ADDENDUM NO. 1
TO THE BID DOCUMENTS
Main Street Sidewalk Improvement Project
CITY OF HOMER, ALASKA

Addendum Issue Date: April 22, 2022

Issued By: Janette Keiser, PE
Public Works Director
City of Homer

CITY OF HOMER
MAIN STREET
SIDEWALK IMPROVEMENTS
PLAN AND PROFILE
PIONEER AVE
BOP TO 15+00

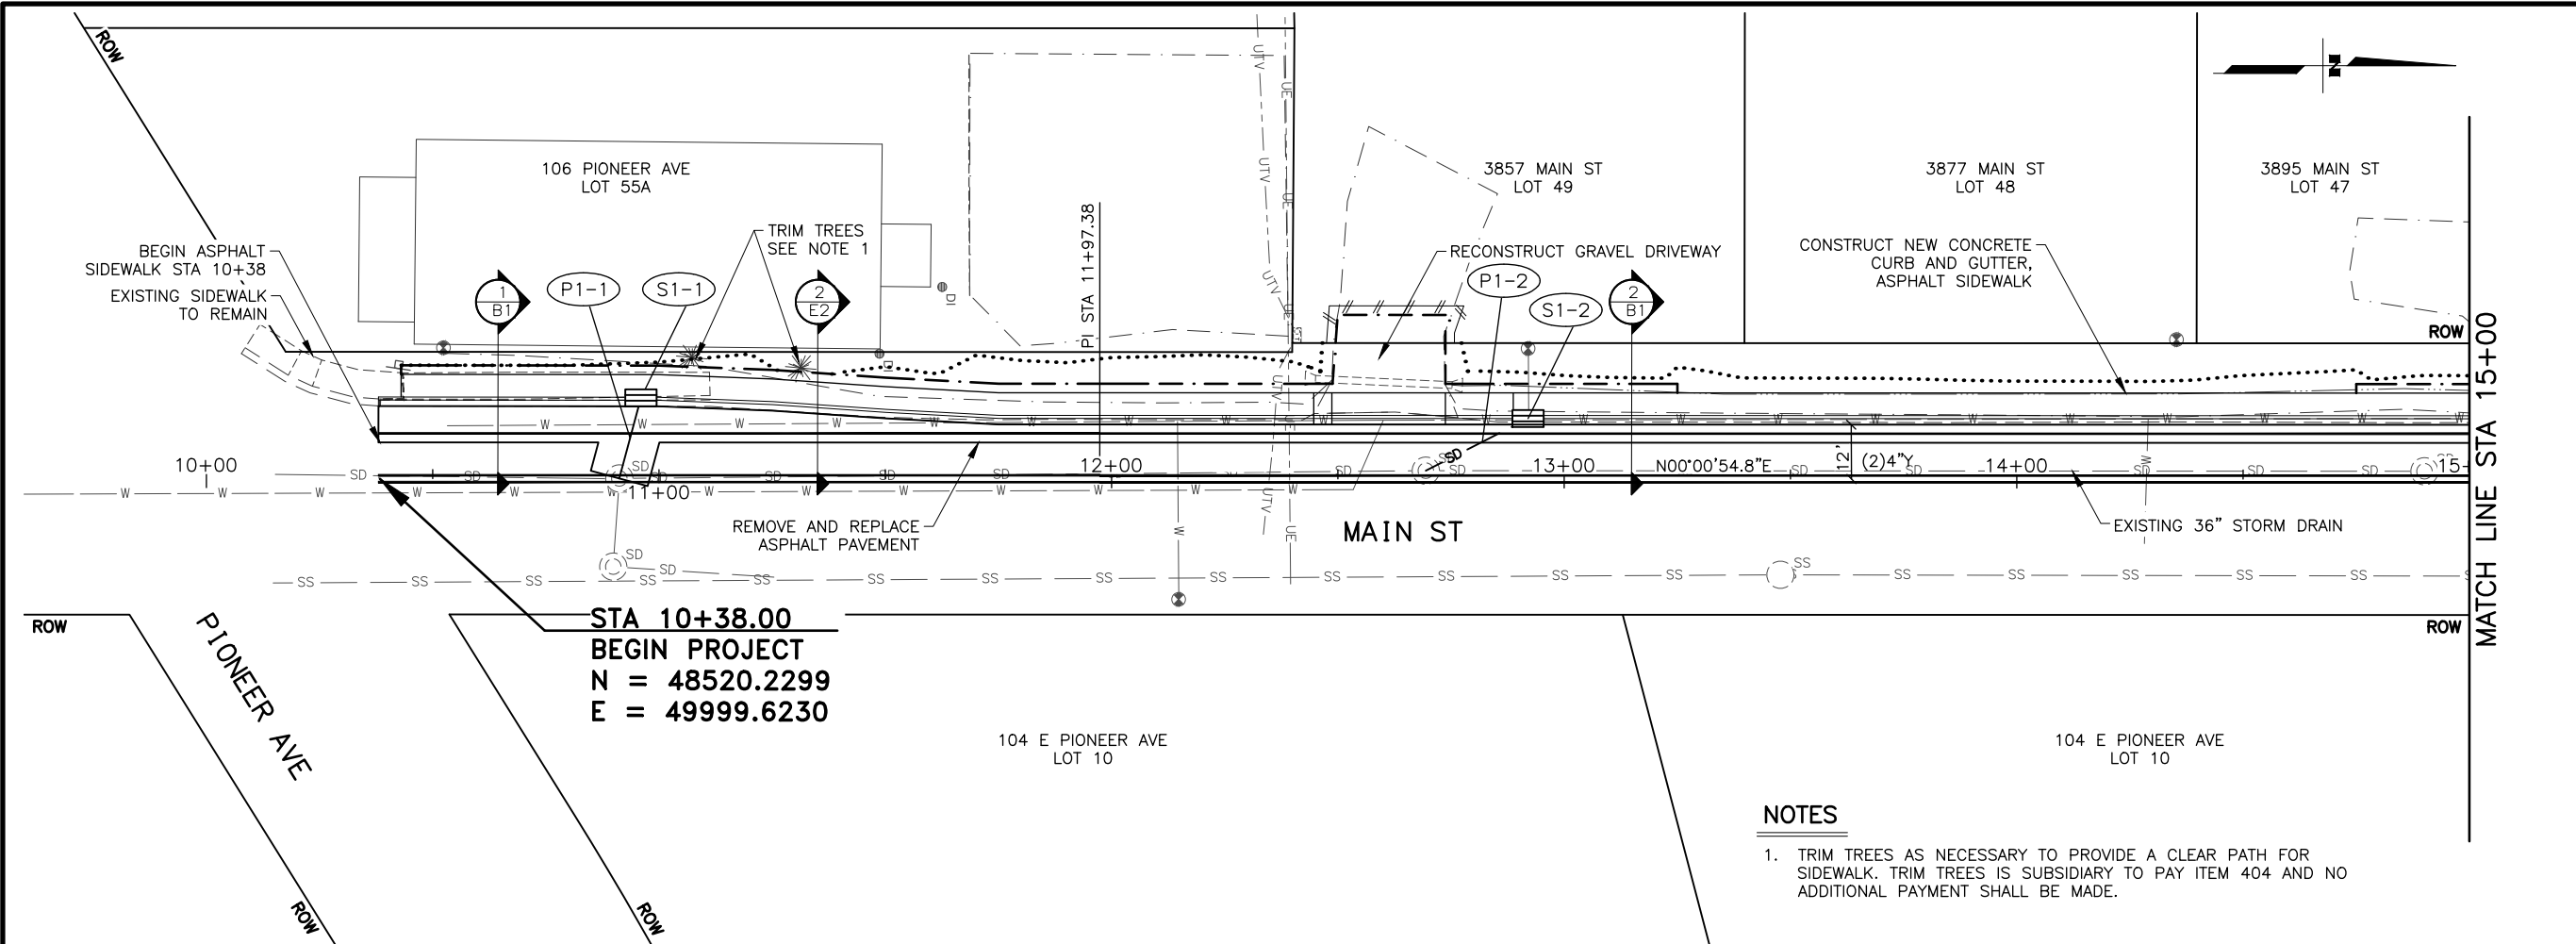
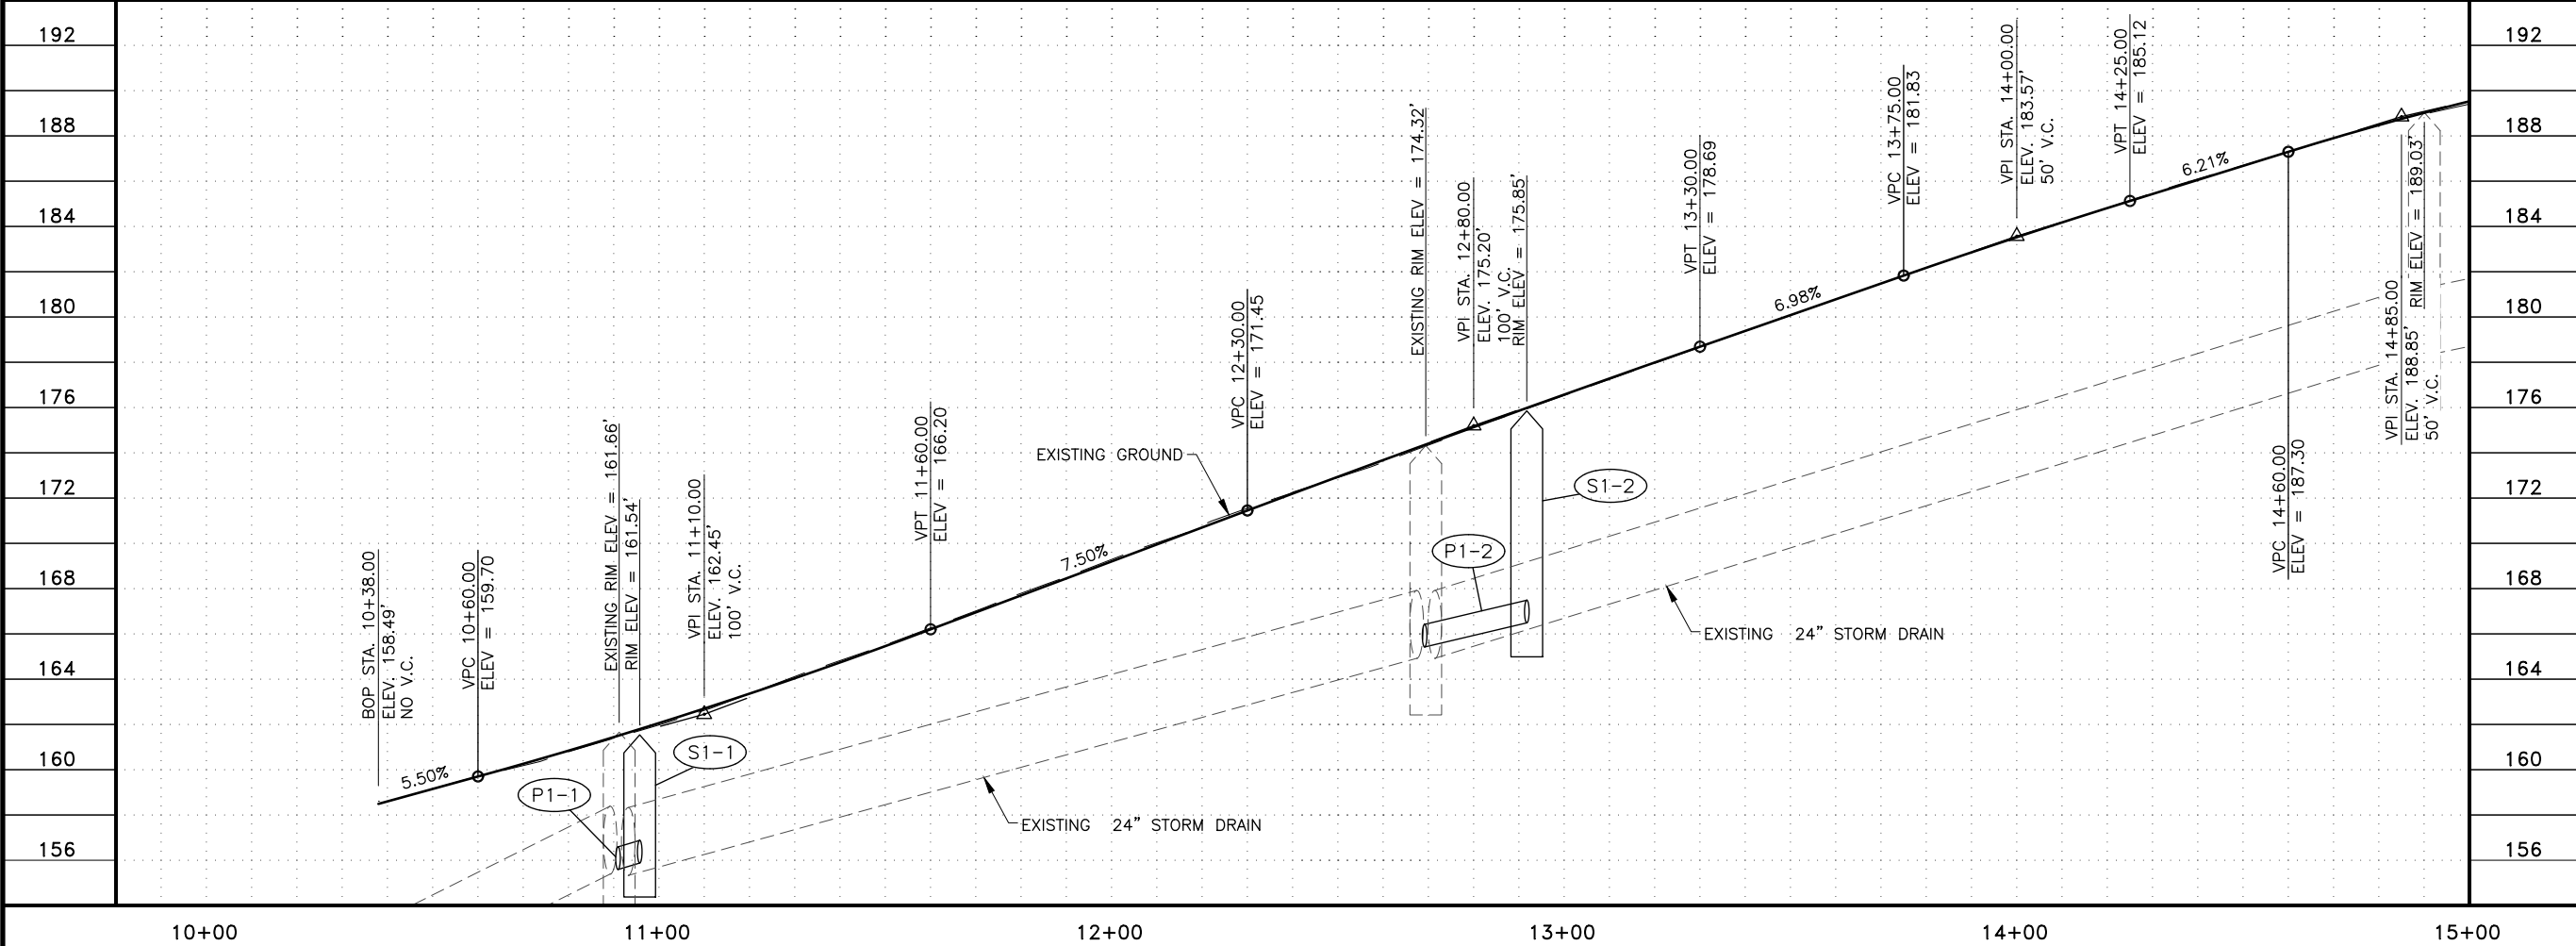
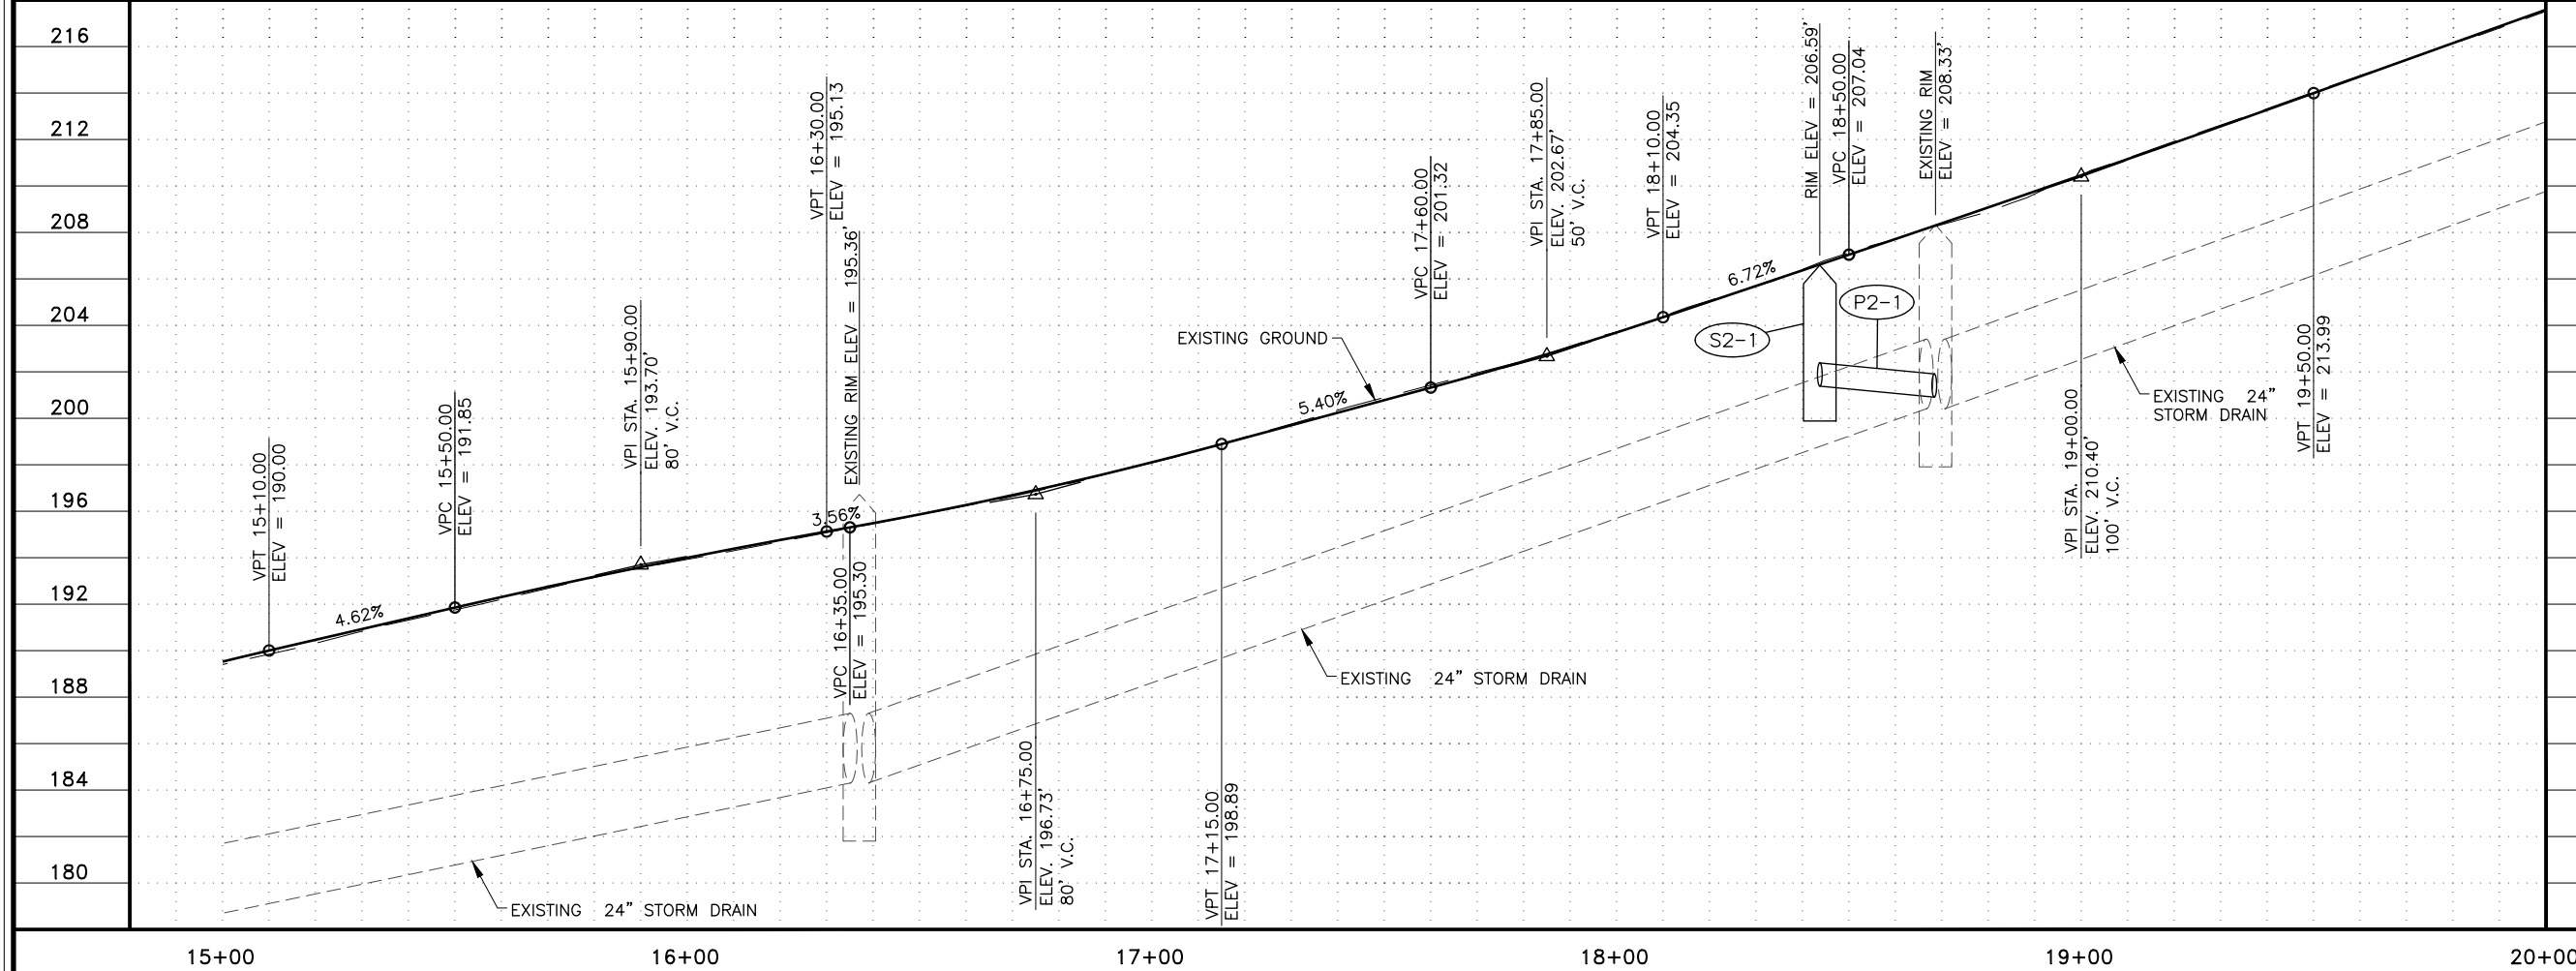
The City noticed that the existing storm drain pipe section from Pioneer Avenue to Fairview Avenue on sheets F1 – F4 of the plans has been mislabeled as 24” pipe when it is actually 36” pipe. The transition from 36” pipe to 24” pipe is made at the manhole closest to Fairview Avenue shown on sheet F4. Additionally, the City noticed that the invert elevations of the existing manholes were not indicated on the plans. To clarify both of these points, we have attached as-builts for the existing storm drain pipe. It should be noted that these as-builts use the NGVD 1929 datum rather than the NAVD 1988 datum used by the plans.
